UNITED STATES PATENT AND TRADEMARK OFFICE

| APPLICATION NO. | FILING DATE | FIRST NAMED INVENTOR | ATTORNEY DOCKET NO. | CONFIRMATION NO. |
|--|-------------|----------------------|---------------------|------------------|
| 10/608,701 | 06/27/2003 | Mark V. Vandewalle | 5490-000283 | 9681 |

Office Action Summary

Figure 1

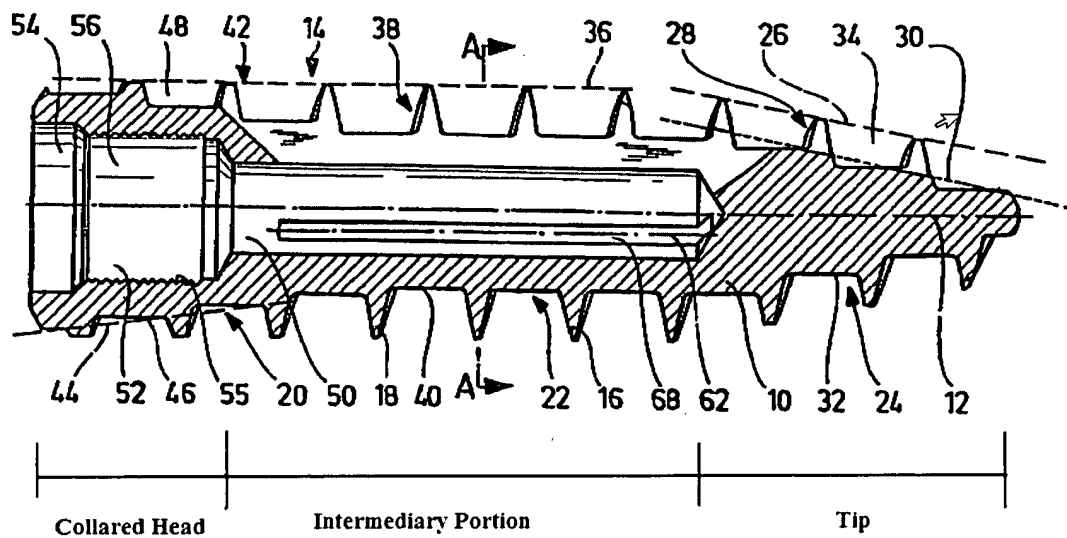
Schultheiss et al. discloses a bone screw anchor (10) that is operable to secure an implant to a bone that has and externally threaded (14) intermediary portion; a pointed self-tapping tip, comprising of a cutting flute that extends across a part of the intermediary portion, located at a first end of said intermediary portion; a collared head, comprising of a cutting flute, located at a second end opposite of said tip that has an interface capable with a driving tool; and a threaded interior (55) bore (50) extending through said head and through said intermediary portion, where it is operable with threads of the fastening device (a screw) to secure the implant to the bone (see Fig. 1 below). Schultheiss et al. also discloses a port (62) on the sides of the anchor that can communicate with the interior bore (50) that is at least partially filled with bone cement, an intermediary portion that is completely threaded that has a larger diameter than the tip and an interface of said head that has at least one recess (54) operable to mate with said driver.

Schultheiss et al. discloses the method steps of securing an implant to a bone which includes implanting a bone screw anchor within the bone using a driving tool operable with the head of the anchor; injecting bone cement into a threaded bore extending through the head to at least a portion of the intermediary portion using a cement delivery device that allows the anchor to be secured; and securing the implant to the anchor using a threaded fastening device secure within the bore. Schultheiss et al. also discloses that the internally threaded portion is inherently protected during the ejecting step, the delivery device is connected to the internal thread of the anchor to protect the threads from being contaminated with bone cement during the injecting step and the bone cement exits at least one port located on the side of the anchor.

Figure 2

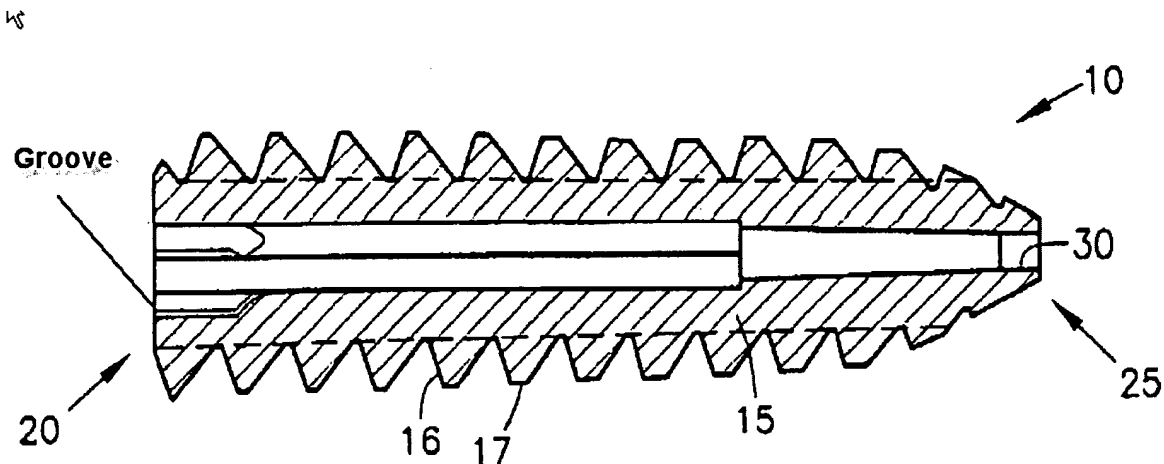
Schultheiss discloses the claimed invention except for and open tip or a screw head having grooves. Wolf discloses a groove to receive a driving tool to optimize

torque capacity when inserting the device. Wolf also discloses an open tip (30) so that a guide pin may be used during delivery and installation. It would have been obvious to one skilled in the art at the time the invention was made to construct the device of Schultheiss with a head defining a groove as well as an open tip in view of wolf, in order to have a device that can be installed with ease and accuracy.
